Tender Queries

City College Plymouth

T-Level Improvements

Queries 88/ 88E from Contractors.

PROPOSED SOUTH WEST ELEVATION
EXCERPT SHOWING EXTERNAL BOTTLE STORE

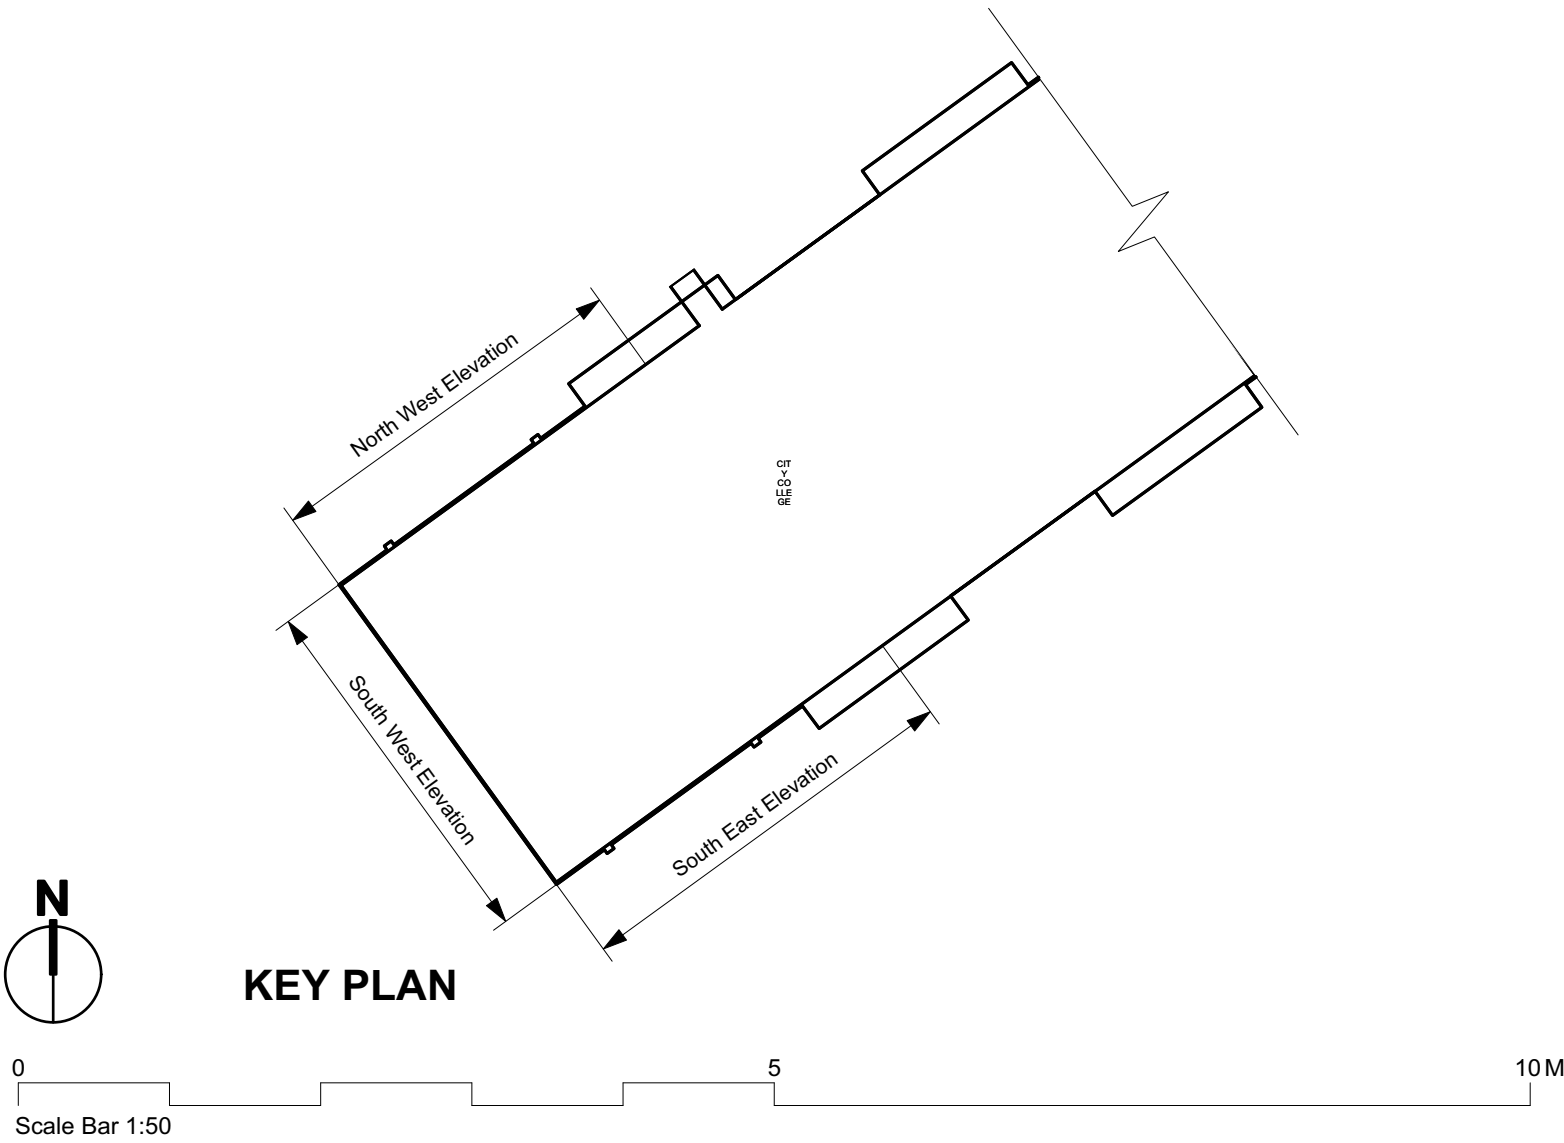
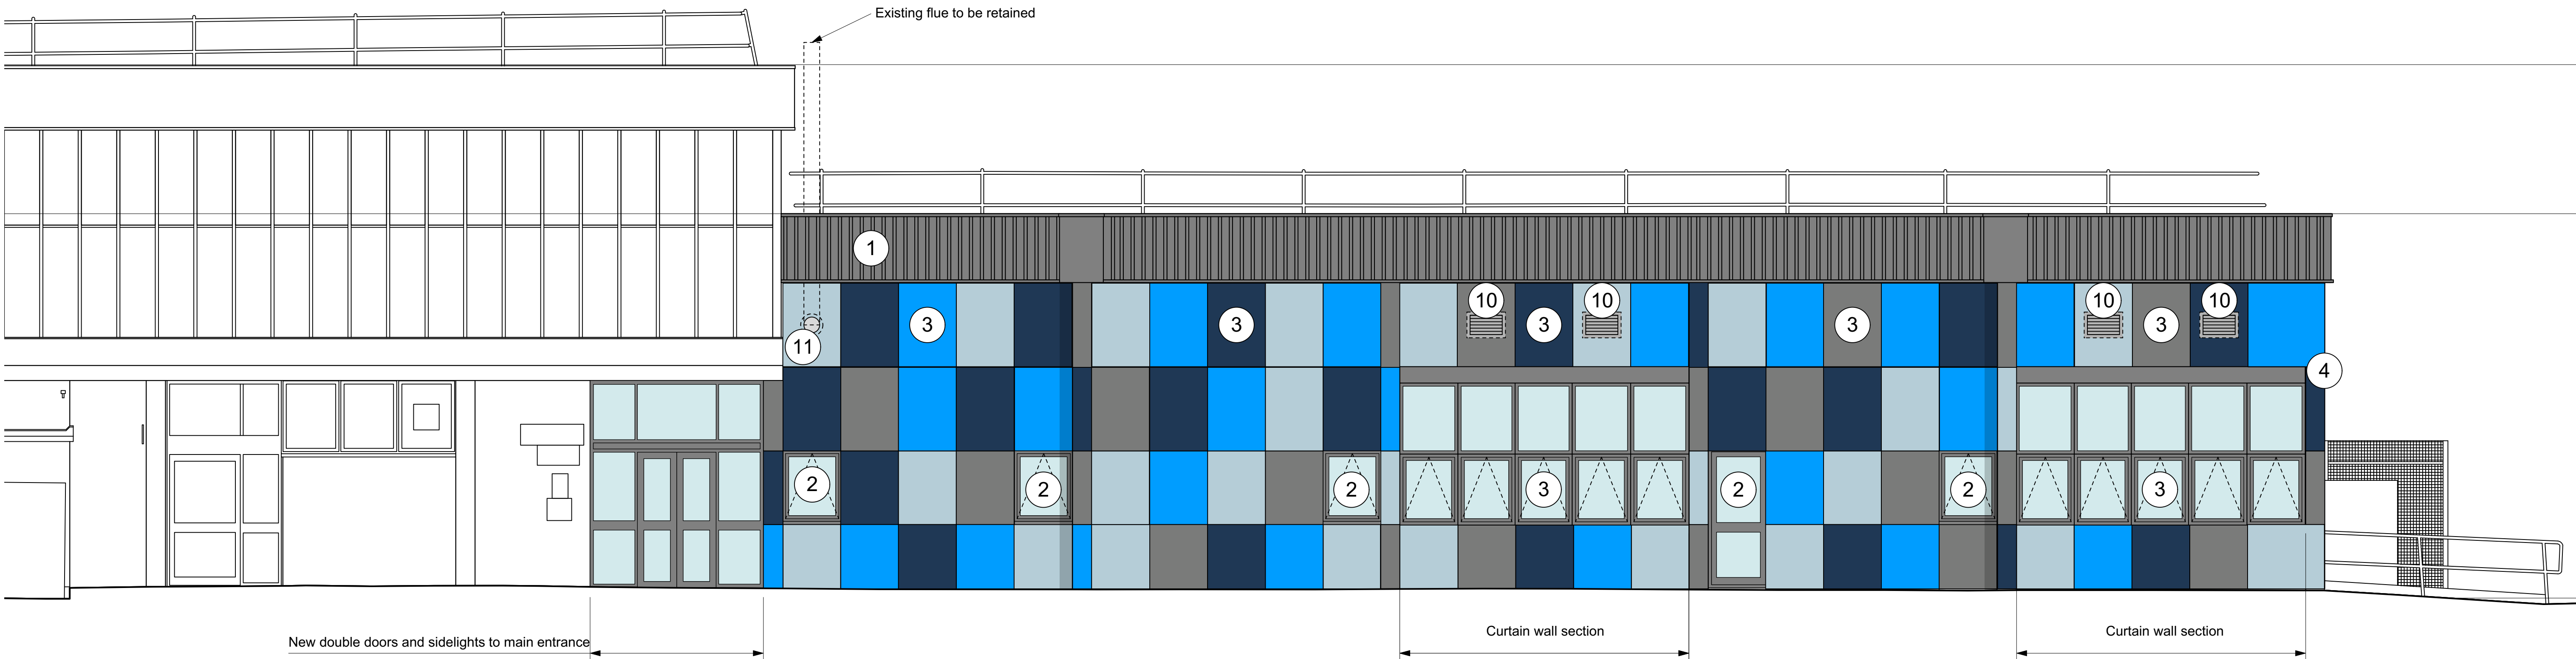
Ref	Description	KKL Comment
I	Drawing shows 2 no ground floor windows replaced (Item 2 ?) but query all new windows T B A (Ground and 1st ?)	Yes, all windows please. Please see revied drawing for clarity.
J	Drawing does not show 1st Floor window infilled (adjacent stair door ?)(query not in scope doc ?) - NB - query door 1st floor marked in red on drawing 02B?	Please see revied drawing for clarity showing infilled window. FF door is to be removed and replaced as per Works Section 4.05.1
K	Note - 2 no windows Ground Floor behind bottle store screen removed / infilled (query not in scope doc ?)	Allow for windows to be removed and infilled. Existing openings to be used for mechanical ducting openings. Please see elevation AL(2)17D in Appendix A
L	Note - Drawing Al (2) 01B shows all windows and doors on Ground floor being removed query ?	Yes, and to be replaced

Drawing Title
Proposed North West Elevation

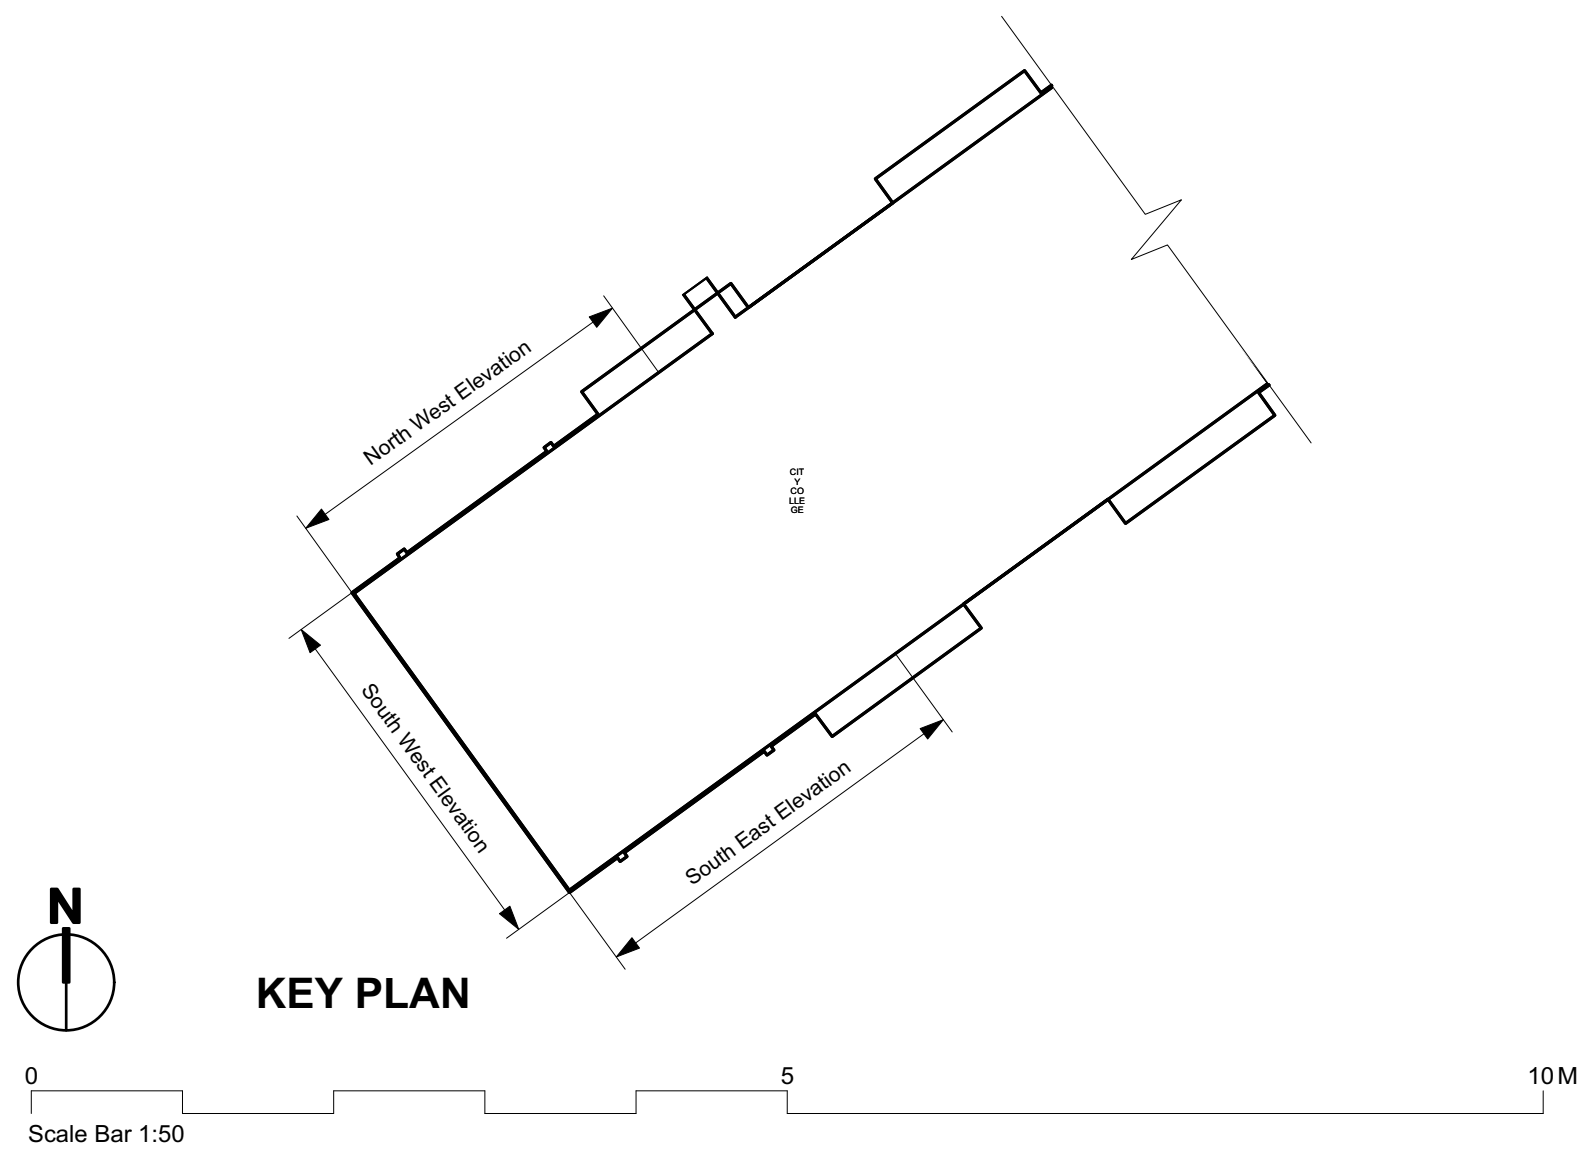
Ref	Description	KKL Comment
D	Query - No window shown in 2nd bay from left adj LH Column - see plan - query - overclad	Window to be remove
E	High level windows to all 5 bays overclad - detail ?	The detail at the head of the window is subject to further on site investigations to ascertain the correct fixing detail into the existing concrete encased steel frame. Detail to follow.
